# SAN FRANCISCO PLANNING DEPARTMENT

**MEMO**

**RE:** **Review and Comment on work proposed to abate Planning Enforcement Case No. 2017-015635ENF, addressing work completed without a Certificate of Appropriateness and proposed expansion of a penthouse and addition of a roof deck and gate, Case No. 2018-009197COA.**

**Re: 1470 McAllister Street**  
**Planning Case No.: 2018-009197COA**  
**Hearing Date: March 6, 2019**  
**Our File No.: 10403.02**

3 AS BUILT ROOF PLAN WITH PROPOSED ROOF DECK  
SCALE: 3/16" = 1'-0"

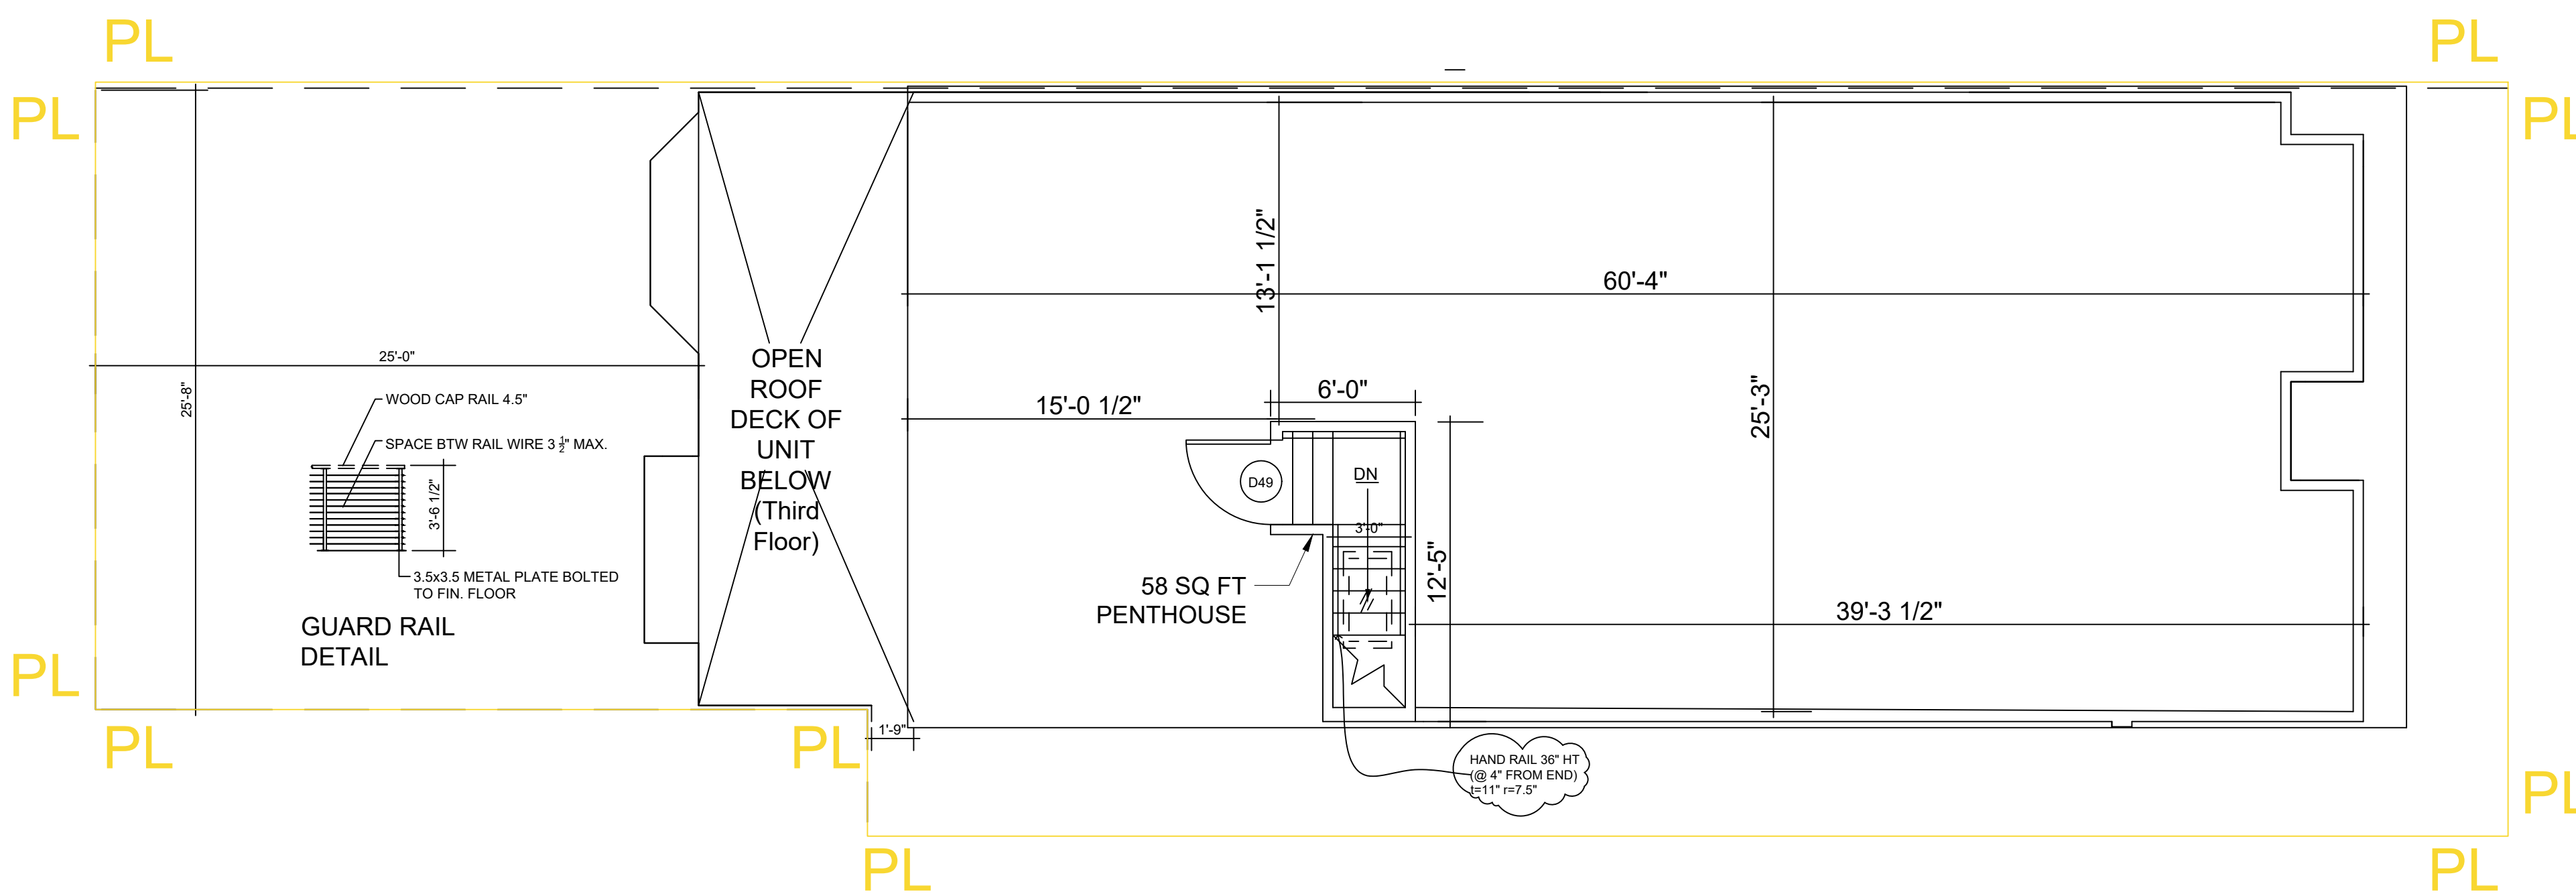
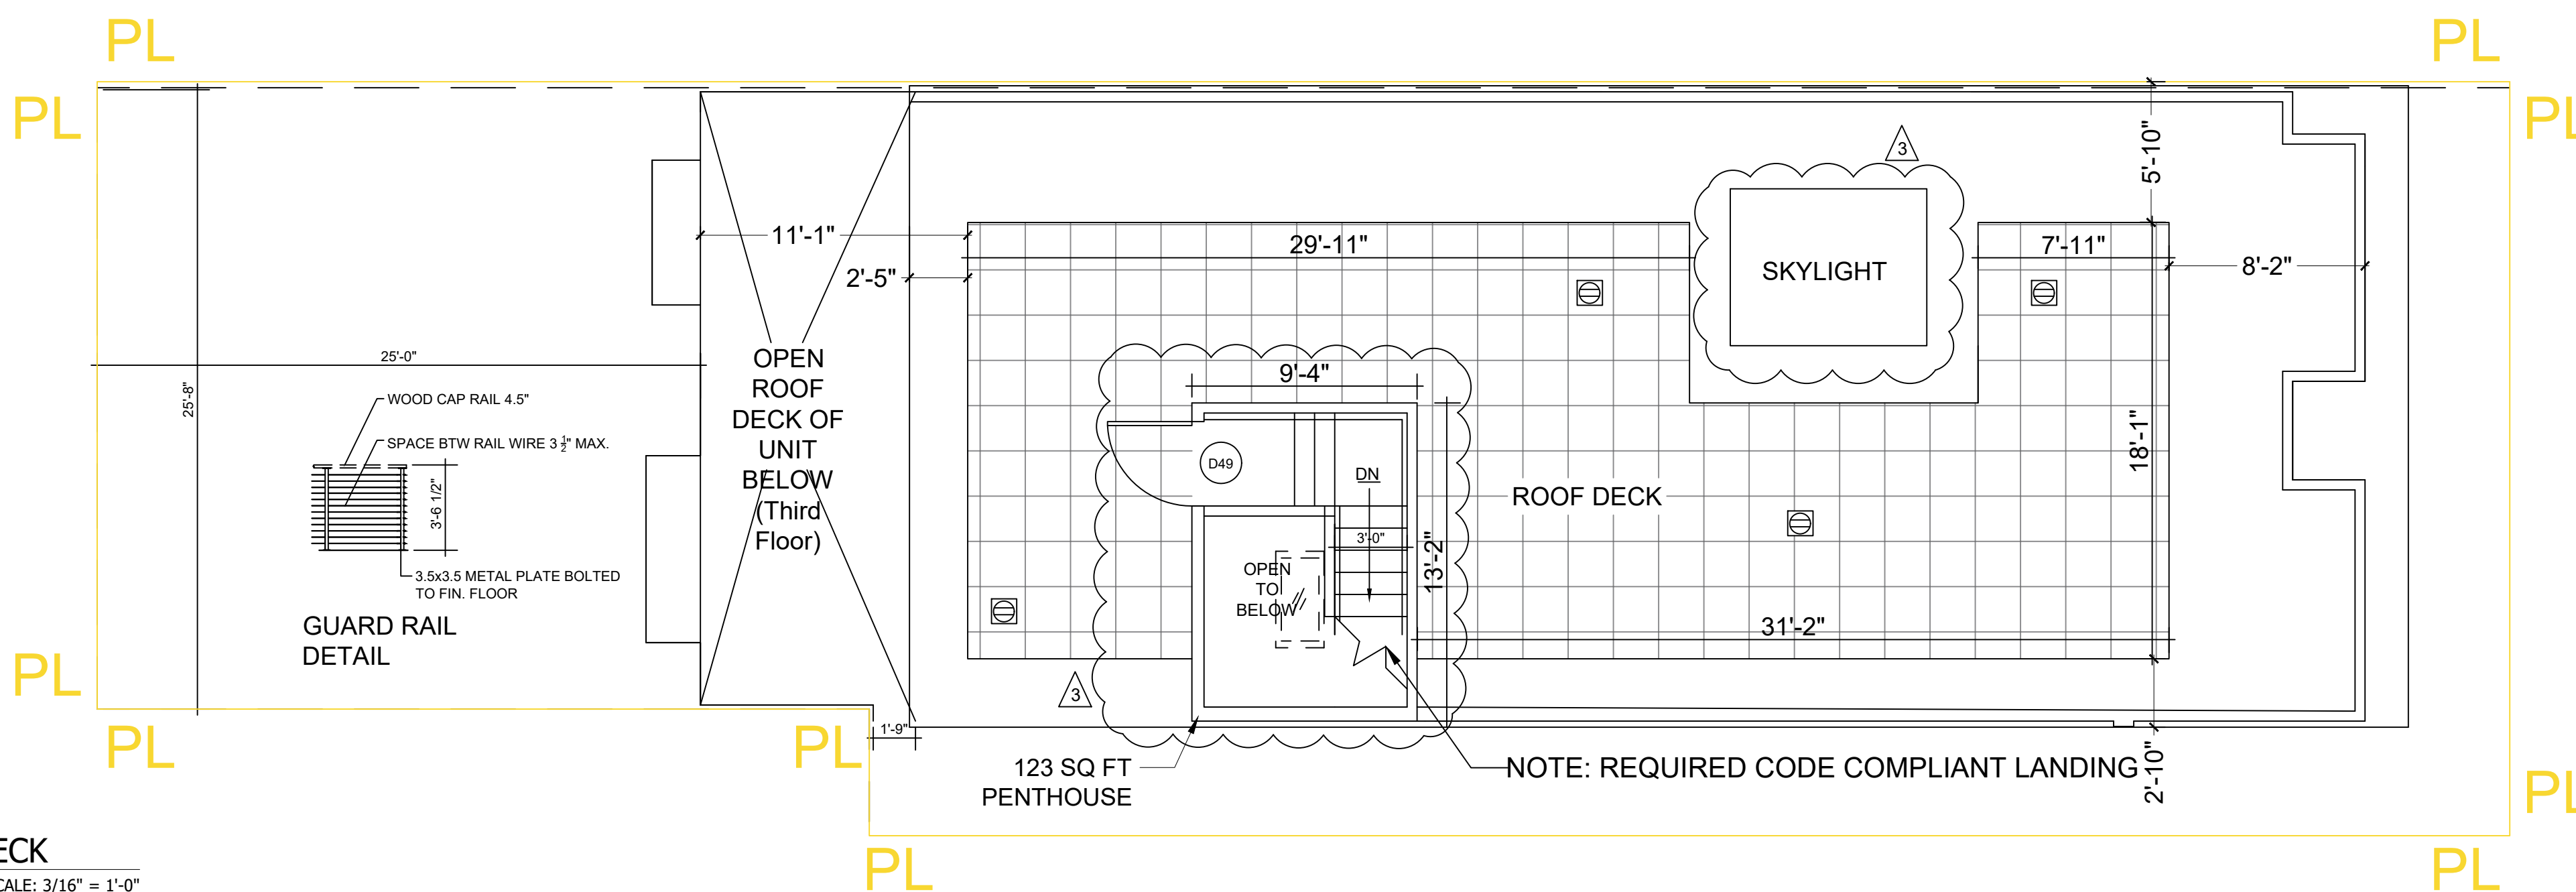
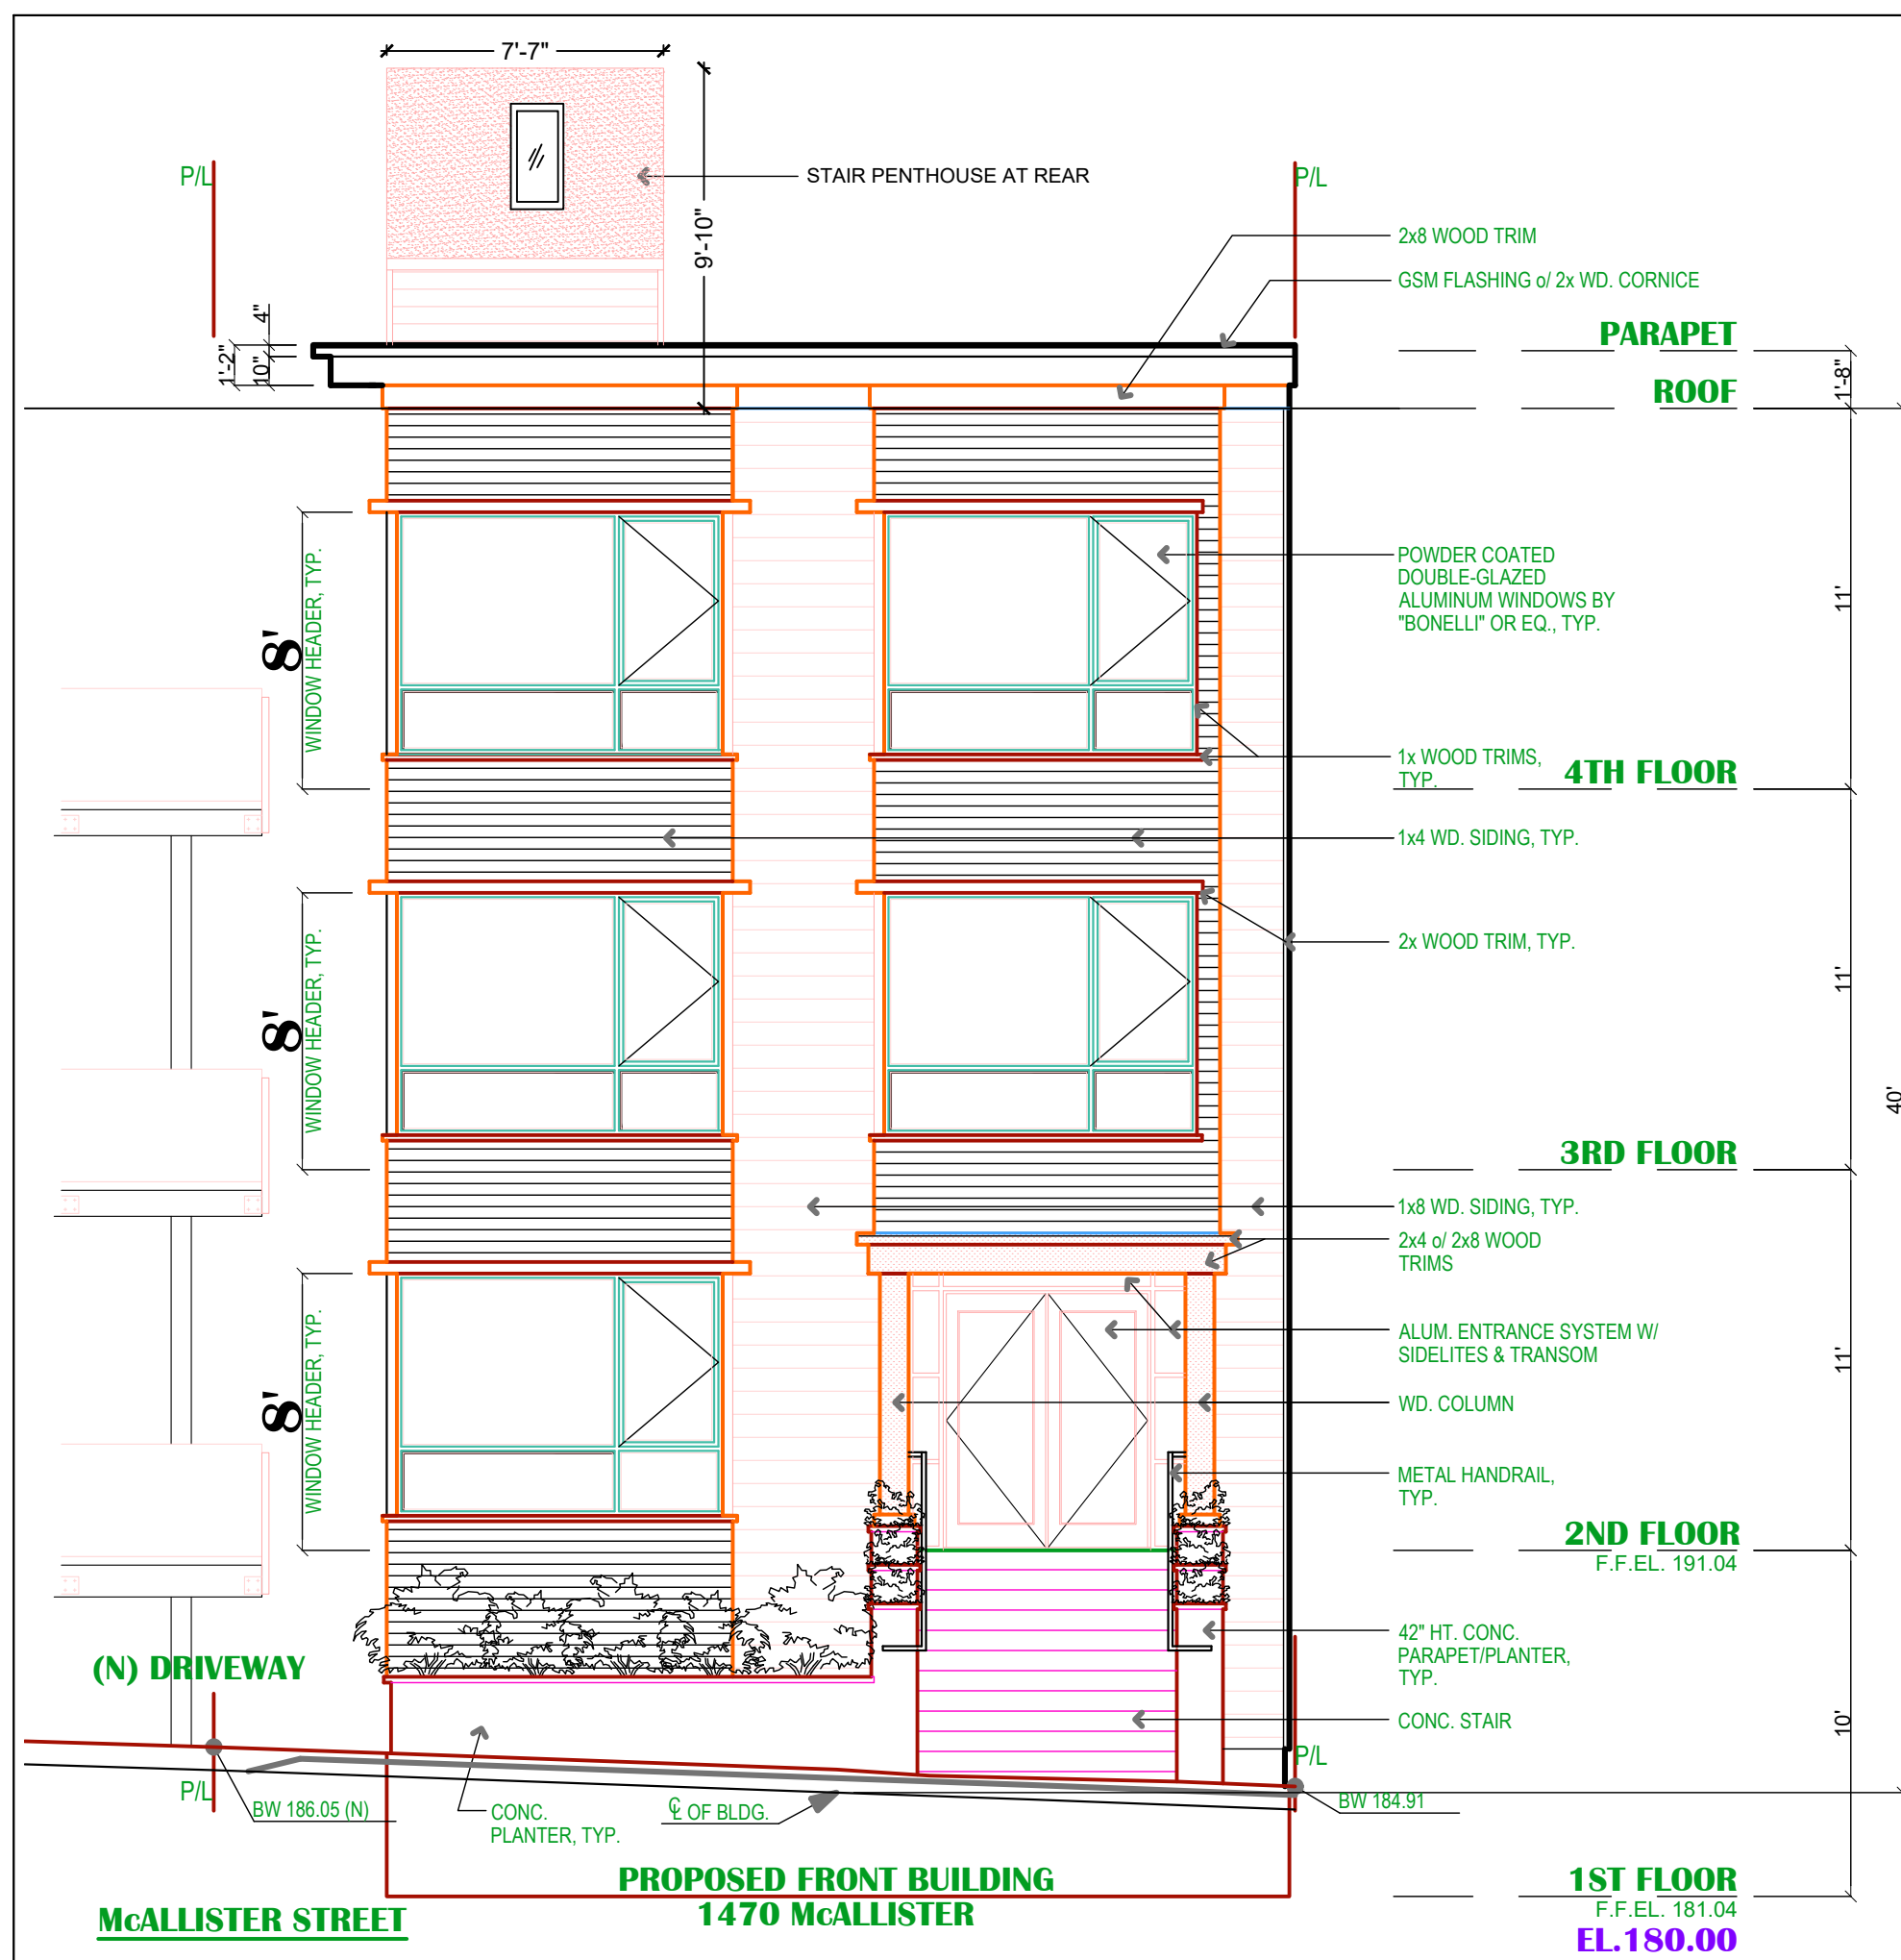
**Recommendation:** The Department recommends the roof deck and guardrails be set back from all edges of building to ensure no sight lines from street or neighboring properties. The project sponsor will provide additional information, such as sightline studies, regarding potential visibility of the proposed roof deck guardrail.

- **Roof Penthouse.** The rooftop penthouse has been an element of the building's design from the outset. The orientation of the rooftop penthouse was changed and approved by Planning. (See Sheets A2.6 [Roof Plans], A3.2-3.4 [Elevations].) Though the penthouse is slightly larger than that previously approved, the difference in size was necessary to satisfy building code requirements for accessibility, including a landing at the top of the stairs before the doorway to the rooftop. The as-built rooftop penthouse is not visible from the public right-of-way as shown in Sheet A4.1 [Photographs]. Likewise the proposed roof deck also would not be visible from the public right-of-way and will not detract from the historic neighborhood.
